**Re: Closure Request
PLU 28 BS West Battery
Incident Number nAPP2517851300
Eddy County, New Mexico**

Ensolum, LLC (Ensolum), on behalf of XTO Energy, Inc (XTO), has prepared this *Closure Request* to document the findings of a liner integrity inspection conducted at the PLU 28 BS West Battery (Site) following a release of produced water within a lined containment. Based on the liner integrity inspection activities, XTO is submitting this *Closure Request*, describing assessment activities that have occurred and requesting no further action and closure for Incident Number nAPP2517851300.

Operator: XTO ENERGY, INC 6401 Holiday Hill Road Midland, TX 79707	OGRID: 5380
	Action Number: 507559
	Action Type: [C-141] Remediation Closure Request C-141 (C-141-v-Closure)

FIGURE
1

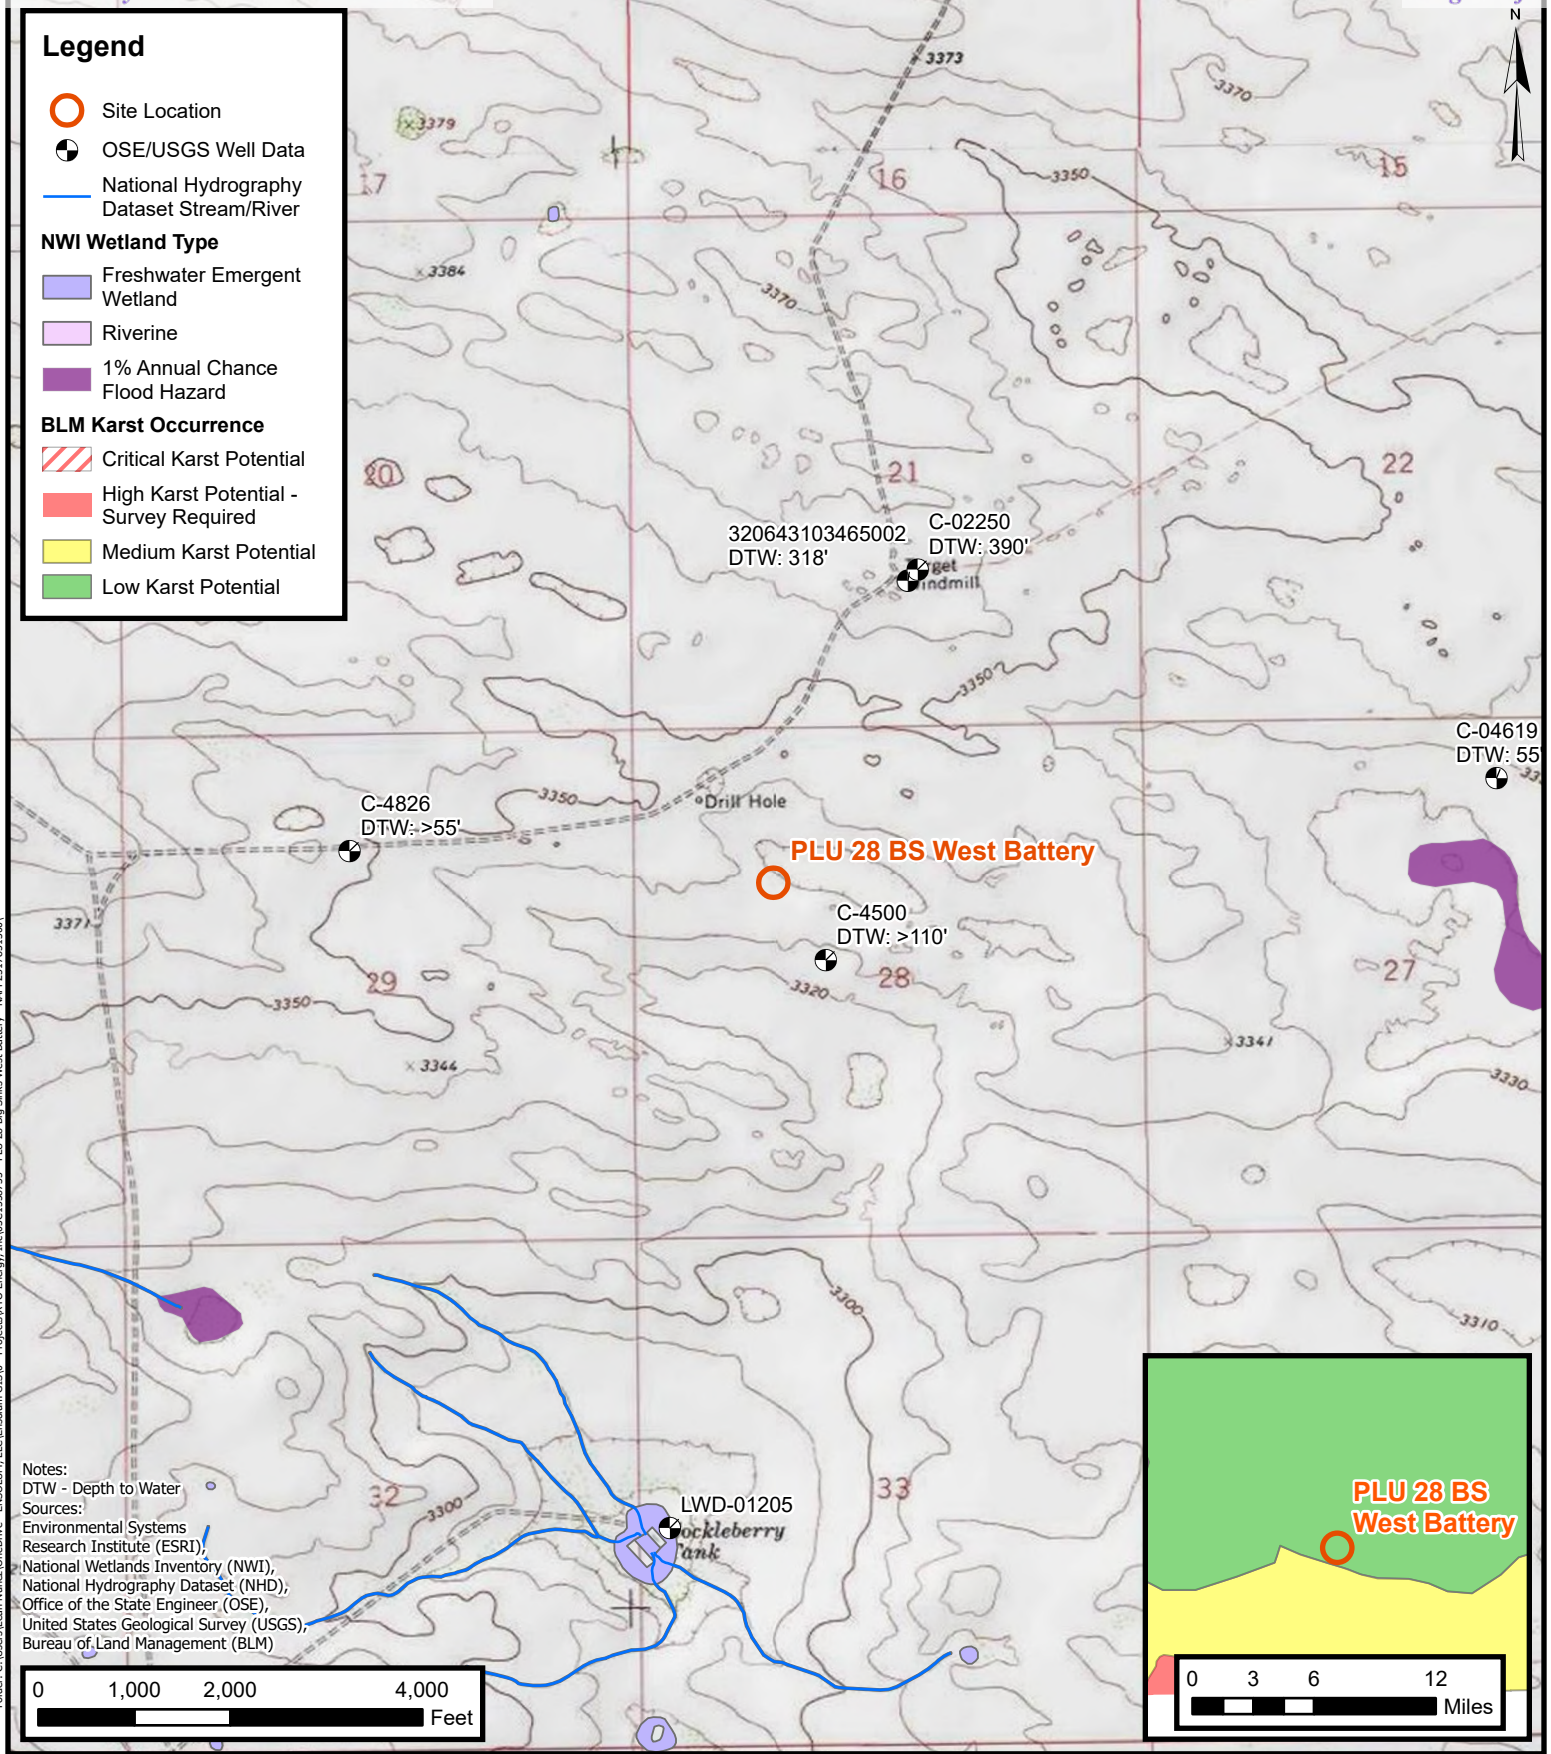
Created By	Condition	Condition Date
scwells	Liner report approved. For future releases at this site, note that the distance to "Any lakebed, sinkhole, or playa lake (measured from the ordinary high-water mark)" should be updated to "Between 1 and 5 (mi.)", as there are many playas south of the site, as seen on the attached Figure 1.	9/26/2025
